JOINT REGIONAL PLANNING PANEL (Sydney West)

| DA Number | DA0327/13 |

742-746 PACIFIC HIGHWAY, GORDON – SUPPLEMENTARY REPORT

| PURPOSE FOR REPORT: | To address the issues raised by the Sydney West Joint Regional Planning Panel (JRPP) at the 8 April 2015 meeting and for the JRPP to determine Development Application No. 0327/13 for the demolition of existing dwellings and construction of a hospital at 742-748 Pacific Highway, Gordon. |

Figure 2 - amended proposal showing the reduced height non-compliance.

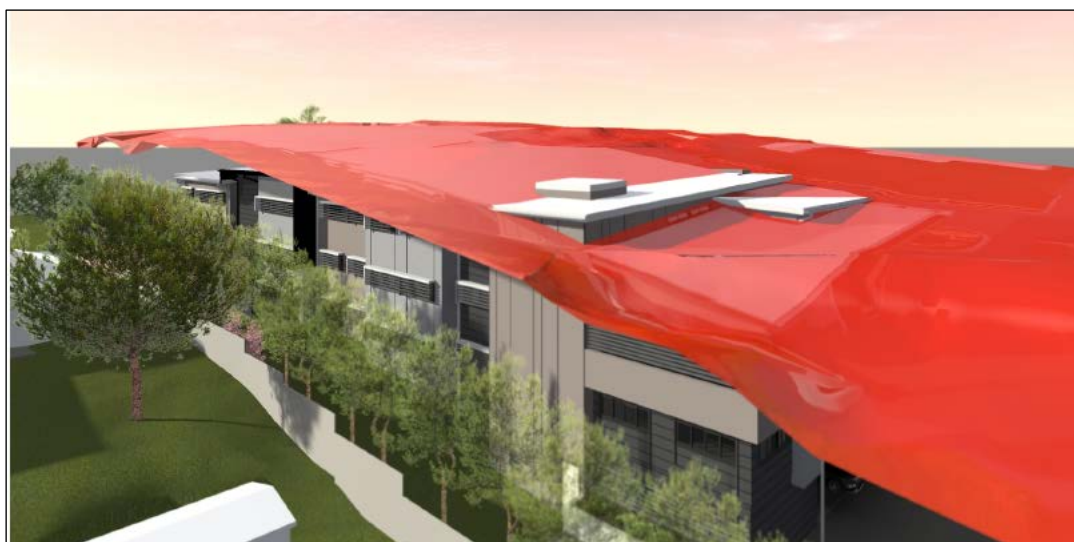
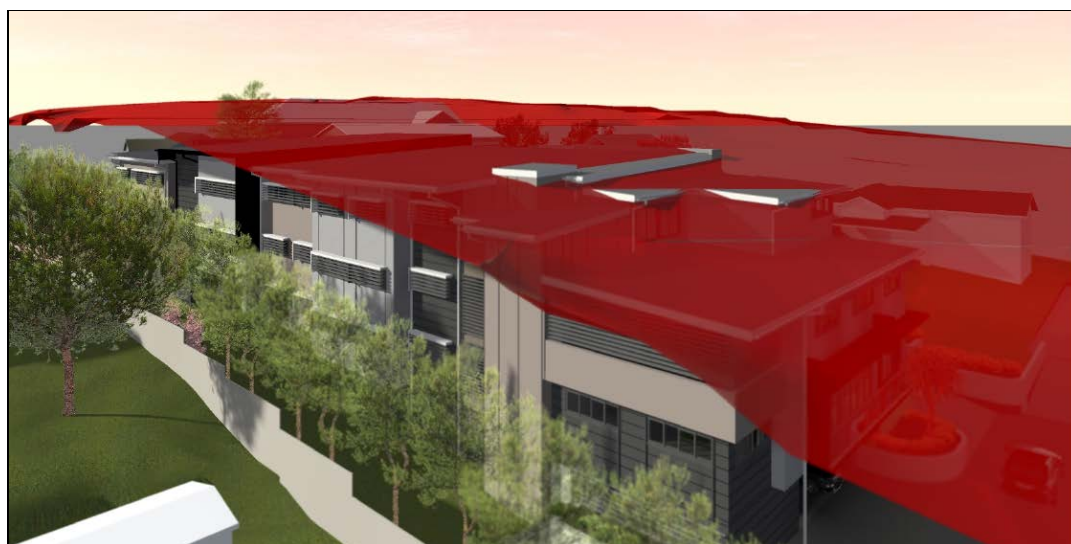
a) reduction of the height non-compliance to the greatest extent practicable by adjusting the Western lift bay and stairwell.

The applicant has reduced the height non-compliance from 1.3metres to 690mm.

The plans have been modified by re-orientating the stairs and lift, which has reduced the overall height in the southern part of the building. The height non-compliance at its maximum is now 690mm. A detailed amended Clause 4.6 variation request (**Attachment A**) to the height standard was submitted on the 27 April 2015. The request contains detailed justification as detailed below under the Clause 4.6 variation request assessment.

Figure 3 showing setbacks from the side boundaries of the non-compliant height elements of the proposed building.

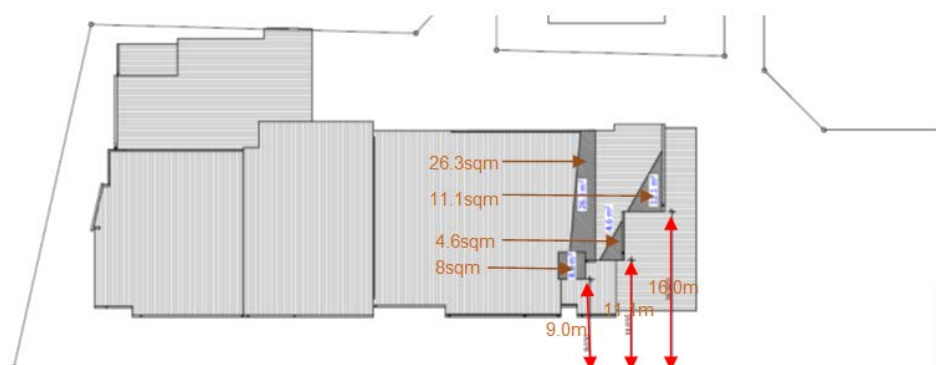
It is considered that the proposed variation to the development standard raises no matter of significance for state or regional environmental planning and that there is no public benefit in maintaining the development standard in this particular case.
